**Safety Defect and Noncompliance Report Guide for Vehicles**  
**PART 573 Defect and Noncompliance**

On February 27, 2003 Damon Motor Coach decided that (a defect which relates to motor vehicle safety)(a noncompliance with Federal Motor Vehicle Safety Standard No. 105 S5.3) exists in the motor vehicles listed below, and is furnishing notification to the National Highway Traffic Safety Administration in accordance with 49 CFR Part 573 Defect and Noncompliance Reports.

**SUBJECT:** Certain 2000 through 2003 Model Year F53 Chassis - Brake Warning Indicator

**INSTRUMENT CLUSTER BRAKE WARNING LAMP CIRCUIT REVISION**

**FIGURE 1**

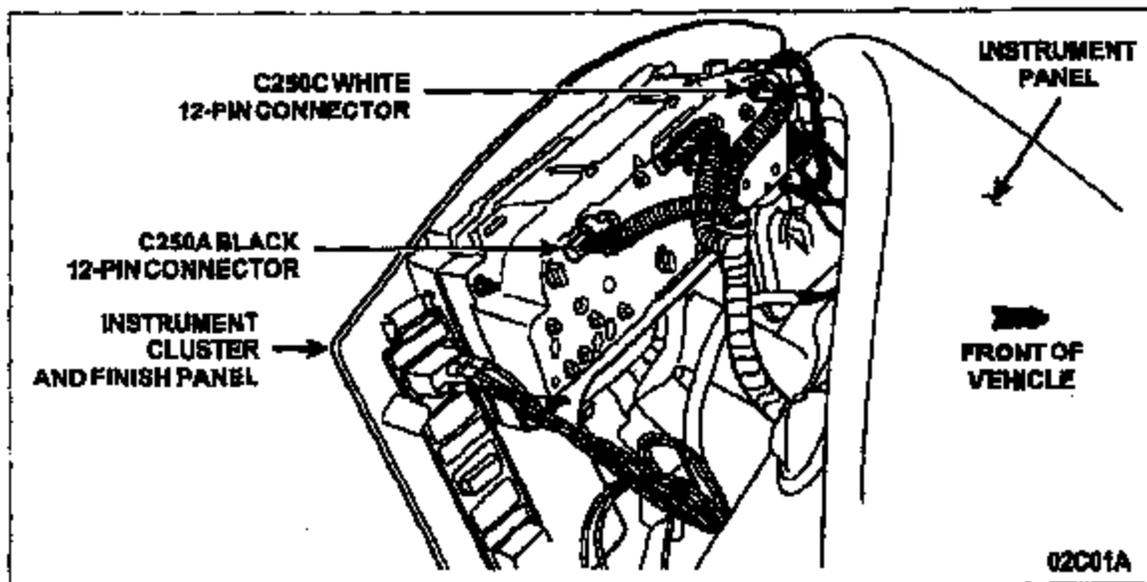
Gain access to and pull the instrument cluster back from the instrument panel.

NOTE: It is not necessary or desirable to remove the cluster from the finish panel, though positioning the shift lever to "1" may be helpful. This should provide suitable access to the repair area. See Figure 1.

2. Disconnect the C250A (black 12-pin connector) and C250C (white 12-pin connector) instrument cluster electrical connectors. See Figure 1.

FIGURE 2

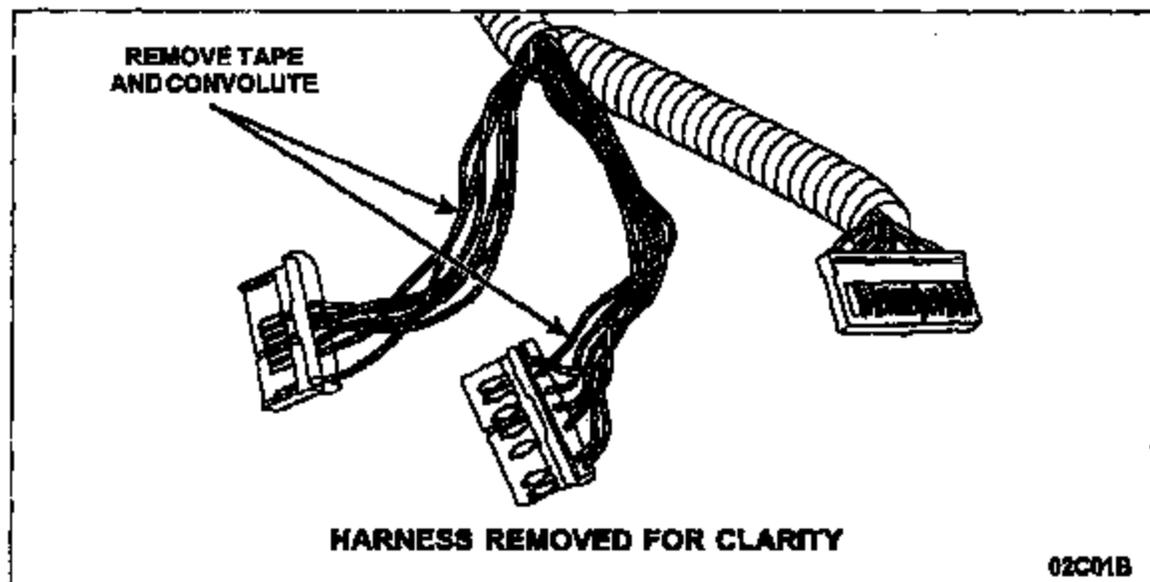
3. Remove the tape and the convolute from the C250A and C250C harnesses up to the point they join the main harness. Retain the convolute. It will be reinstalled. See Figure 2.

FIGURE 3

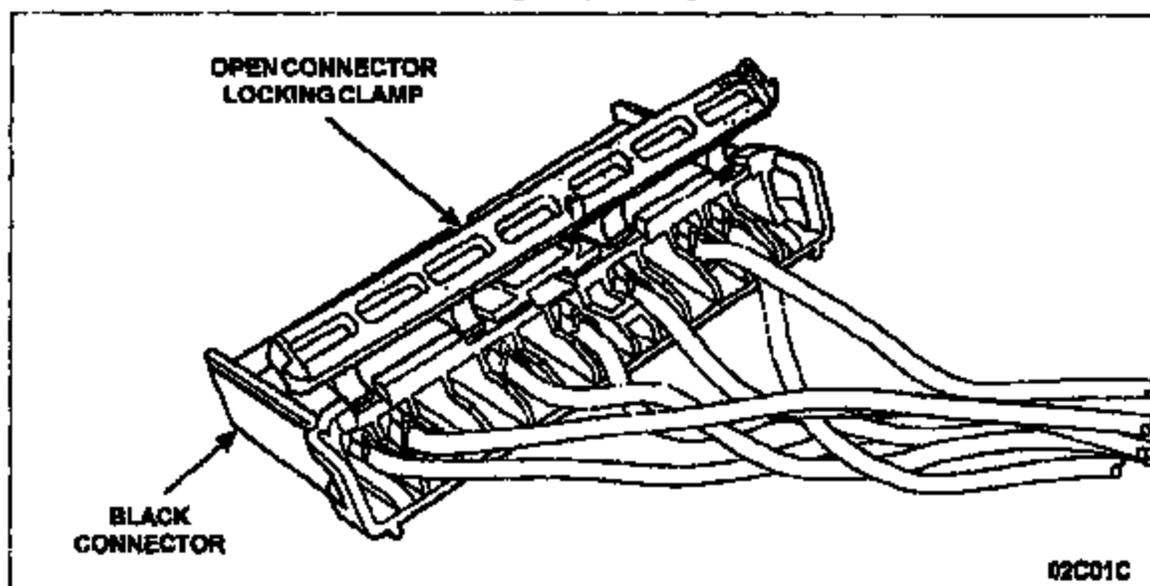
4. Open the black 12-pin connector locking clamp. See Figure 3.

FIGURE 4

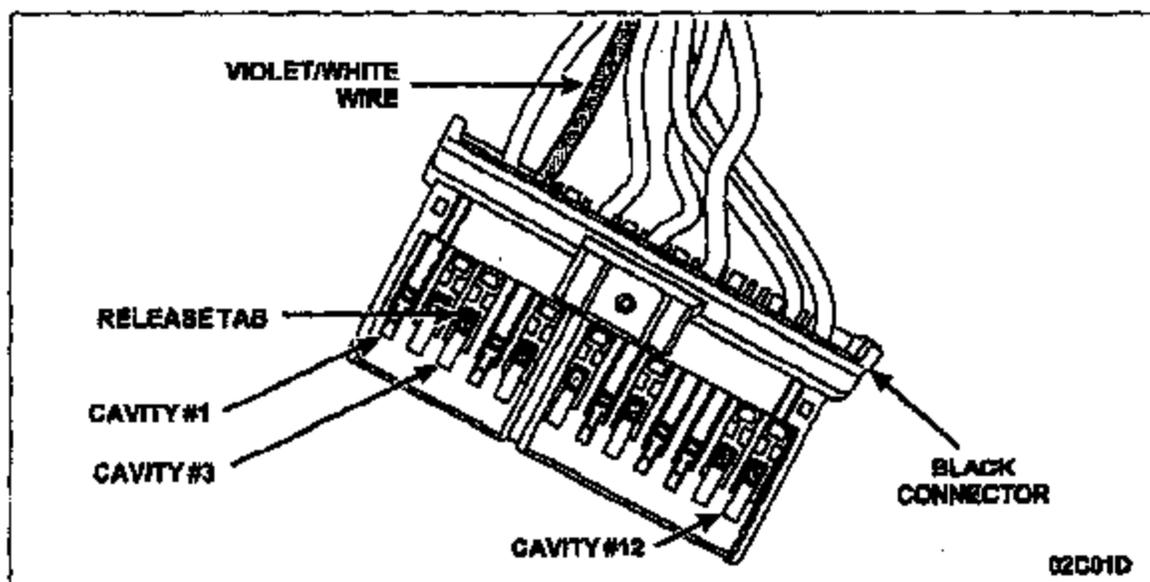
5. Remove the VIOLET/WHITE wire from cavity No. 3 by pushing the small release tab and pulling the wire out of the cavity. Then, close the locking clamp. See Figure 4.

FIGURE 5

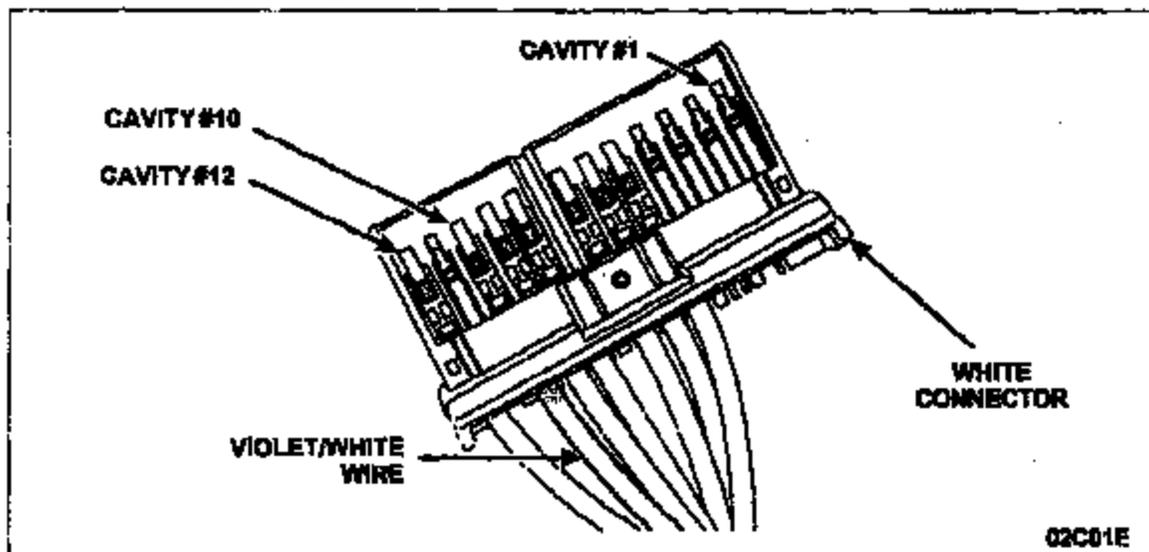
6. Open the white 12-pin connector locking clamp and install the VIOLET/WHITE wire into cavity No. 10. Pull the white wire with light force to make sure it is fully seated. Then, close the locking clamp. See Figure 5.

FIGURE 6

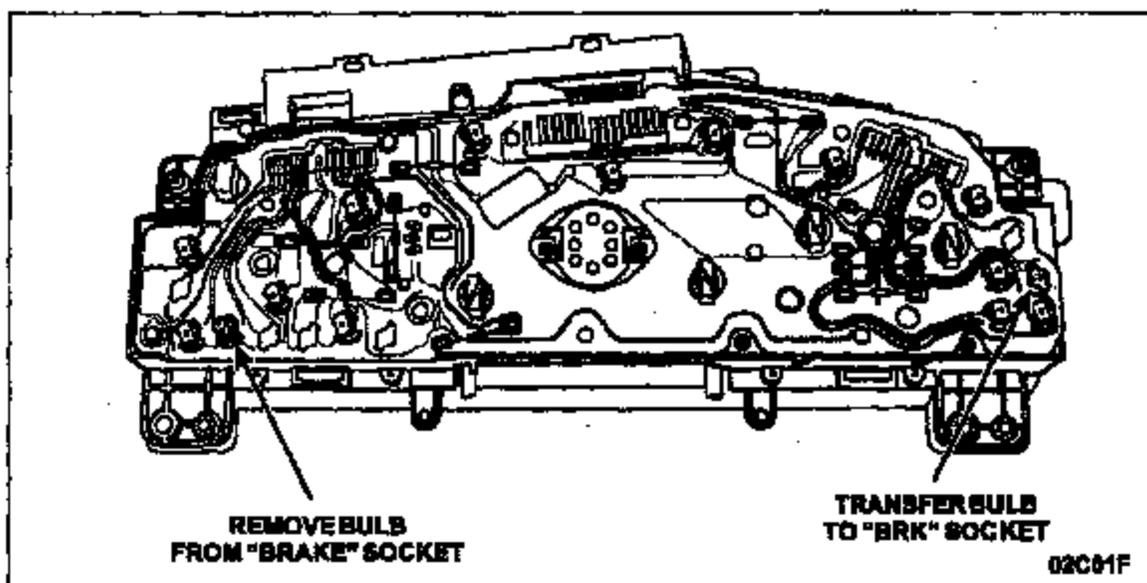
7. Install the convolute and retape both harnesses.
8. Remove the bulb from the "BRAKE" socket and transfer it to the vacant "BRK" socket located on the opposite side of the cluster. See Figure 6.
